Re: Catawba Nuclear Station, Unit 1 Docket No. 50-413 Draft Technical Specifications

This letter transmits our proposed revision to Draft Technical Specification 3/4.7.8 -- SNUBBERS. The justification for the revision was discussed between Mr. Fred Anderson and Mr. Horace Shaw of your staff and representatives of Duke in a meeting held on February 28, 1984. Subsequent discussions and written correspondence have not produced a final resolution acceptable to Duke. A summary of our position is attached.

3/4.7.8 SNUBBERS

Summary of Duke Power Company Snubber Technical Specification History

FIGURE 4.7-1 SAMPLE PLAN 2) FOR SNUBBER FUNCTIONAL TEST

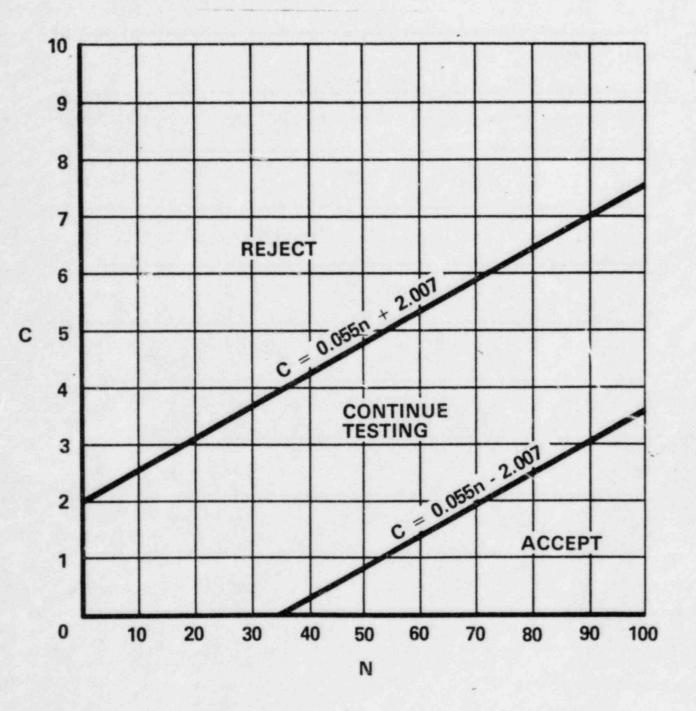
- 2) A representative sample of the snubbers required by Specification 3.7.8 shall be functionally tested in accordance with Figure 4.7-1. "C" is the total number of snubbers found not meeting the acceptance requirements of Specification 4.7.8f. The cumulative number of snubbers tested is denoted by "N." At the end of each day's testing, the new values of "N" and "C" (previous day's total plus current day's increments) shall be plotted on Figure 4.7-1. If at any time the point plotted falls in the "Reject" region all snubbers shall be functionally tested. If at any time the point plotted falls in the "Accept" region, testing of snubbers may be terminated. When the point plotted lies in the "Continue Testing" region, additional snubbers shall be tested until the point falls in the "Accept" region or the "Reject" region, or all the snubbers required by Specification 3.7.8 have been tested. Testing equipment failure during functional testing may invalidate that day's testing and allow that day's testing to resume anew at a later time, providing all snubbers tested with the failed equipment during the day of equipment failure are retested; or
